Title - Sujet Construction Services	
Solicitation No. - N° de l'invitation EZ899-152249/A	Amendment No. - N° modif. 008
Client Reference No. - N° de référence du client	Date 2015-04-23
GETS Reference No. - N° de référence de SEAG PW-\$PWY-019-7491	
File No. - N° de dossier PWY-4-37355 (019)	CCC No./N° CCC - FMS No./N° VME
Solicitation Closes - L'invitation prend fin at - à 02:00 PM on - le 2015-04-30	
F.O.B. - F.A.B. Plant-Usine: <input type="checkbox"/> Destination: <input checked="" type="checkbox"/> Other-Autre: <input type="checkbox"/>	
Address Enquiries to: - Adresser toutes questions à: Ngan, Ken (PWY)	Buyer Id - Id de l'acheteur pwy019
Telephone No. - N° de téléphone (604) 658-2755 ()	FAX No. - N° de FAX (604) 775-6633
Destination - of Goods, Services, and Construction: Destination - des biens, services et construction: CBSA - Pleasant Camp Port of Entry - Pleasant Camp, BC

Please find Addendum No. 4 attached.

Addendum #004

Tender A – Pleasant Camp Port of Entry

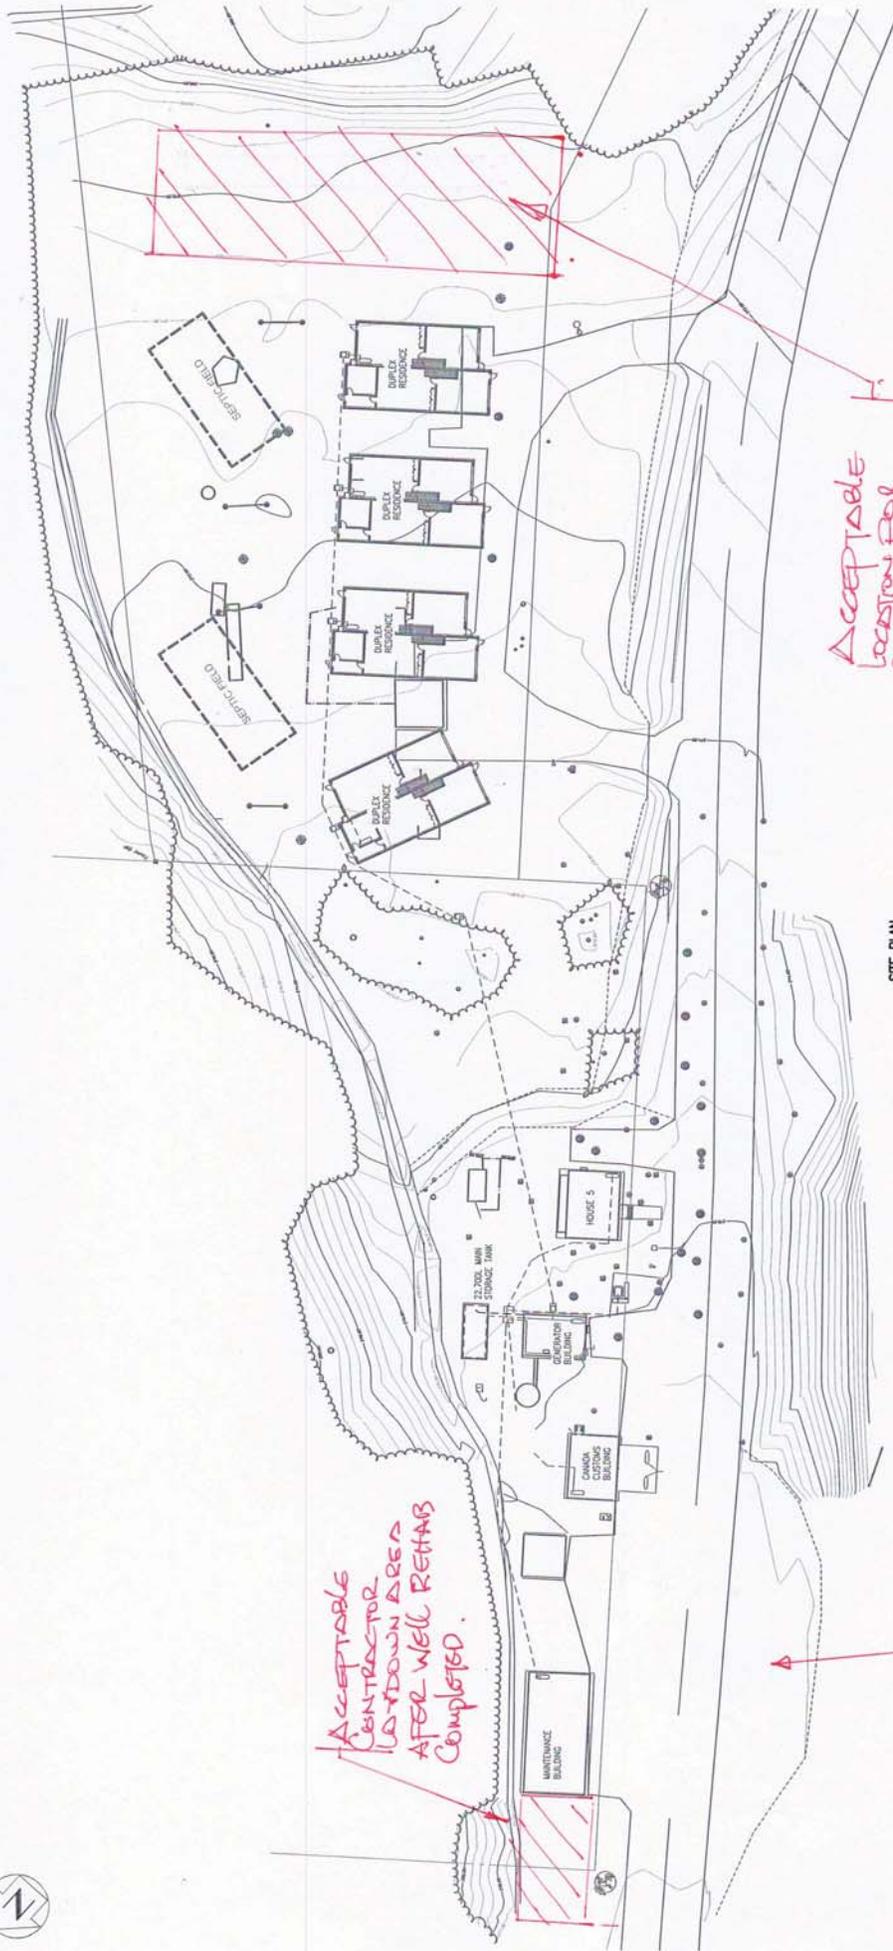
2. Question: Drawing F-008 " Building Fuel Tank Control Panel Schematic " we are being asked to install a new relay in four existing panels, what make are the panels?, do they have enough room?, how far is house #9?

Response:
 1. Panel appears to be "Code Electric", unless that is the enclosure manufacturer. See attached photo.
 2. There appears as if there should be room. See attached photos DSCN0002&3.
